Agenda  
**Special Park Board Meeting**  
Thursday, February 27, 2025  
6:00 p.m.  
East Conference Room #337  
651 Prairie Pointe • Yorkville, IL 60560

**Title:** New Mixed-Density Residential Development (Christie Property) Land Cash Donation

To: Plan Council  
From: Krysti Barksdale-Noble, Community Development Director  
Date: January 31, 2025  
Subject: **PZC 2025-02 Christie Property (Rezone & PUD)**  
Proposed Mixed-Density Residential Planned Unit Development

**Re: Christie Property  
Concept Plan Review  
United City of Yorkville**

## YORKVILLE DEVELOPMENT SITE SITE DESIGN STUDY

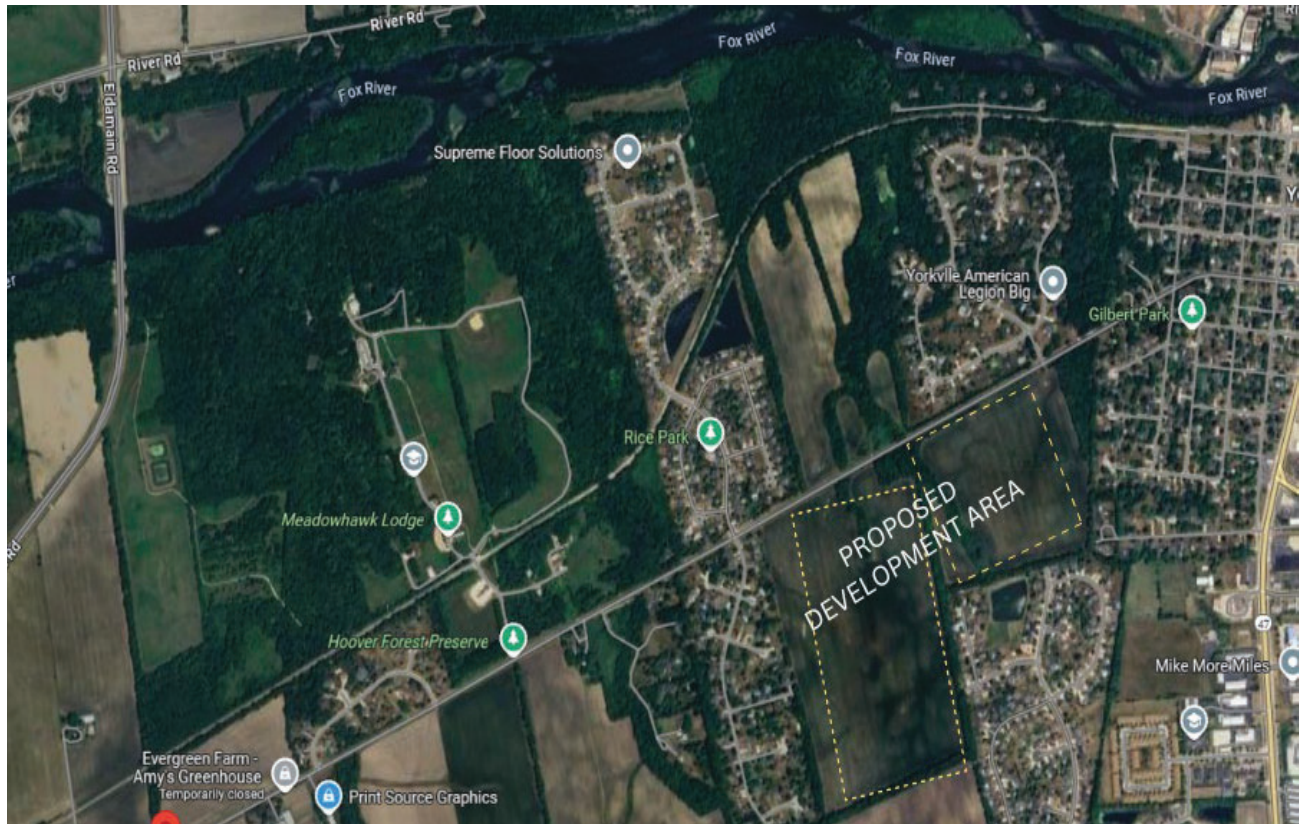
1. The submitted Planned Unit Development (PUD) site plan is presented as a single-sheet sketch in a watercolor format, which has made it challenging to distinguish between the various residential land uses. While the site data table aids in density calculations, **staff recommends providing a hard-lined drawing with greater contrast to better differentiate the residential dwelling types.**

2. The land use plan deviates from the traditional density transition approach by placing higher-density four-plex units at the center, surrounded by lower-density single-family and duplex dwellings. It appears that the petitioner has buttressed the single-family units adjacent to existing single-family developments to the east, south, and north of Fox Road. As this approach to land planning for high-density residential developments is uncommon in Yorkville, **staff recommends including a written narrative with the application to explain the rationale behind this design.**

**Staff found the site data table on the Concept Plan very confusing as to which zoning districts pertained to which dwelling type.**

- i. **It is noted that double-frontage lots exist for the approximately 20 lots which abut Fox Road on the proposed concept PUD plan.**
    - ii. Per Section 10-7-2(D)(2), in these instances, double frontage lots shall be provided with suitable screening. **Since Fox Road is a Kendall County Highway with an equivalent of a City arterial road, the lots must provide a Type D transition yard (refer to #22 Landscape Review Comments below).**

- iii. The double frontage lot may also be subdivided and utilize a separate lot or outlot where the rear property line abuts the roadway for the required transition yard. **It appears the Concept Plan shows this area as a ‘Landscape Easement’ separate from the parcel.**

1. Petitioner will submit a revised hard-lined Concept Plan drawing with greater contrast to better differentiate the residential dwelling types.
2. Petitioner will provide a written narrative with the application summarizing the proposed development, specifically explaining the rationale behind the plan's deviation from the traditional density transition approach by placing higher-density four-plex units at the center, surrounded by lower-density single-family and duplex dwellings as well as the decision not to provide roadway connectivity to Burning Bush Drive.

5. Petitioner shall provide typical lot dimensions on the Concept Plan for each dwelling unit type/proposed zoning designation.
6. Petitioner will provide the proposed minimum unit square footage of livable space for the townhome dwellings.
